Attachment 5
*Applicant's Design
Rationale*

817 St. Andrews St – PASSIVE HOUSE TRIPLEX

This summary is both a response to the *Pre-Application Review for 817 St Andrews* letter of September 28 2020, emails of March 2022 from planning and a Design Rationale.

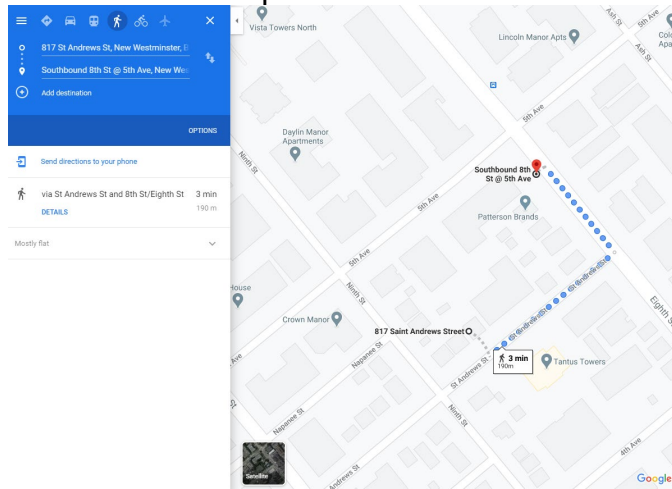
1. HRV exclusion request removed and this area has been added back to the main calculation which brings the project to 0.749 to conform.
2. See associated Arborist report. Only one tree at the rear of the property is proposed to be removed and two new trees added. Adjacent property trees and hedges should not be affected according to the report.
3. Sideyard setbacks have been reduced.
4. A reflected outline of the west facing home has been added to the elevation drawing on sheet A3.1 showing no major privacy issues between new and existing windows. See 2/A3.1.
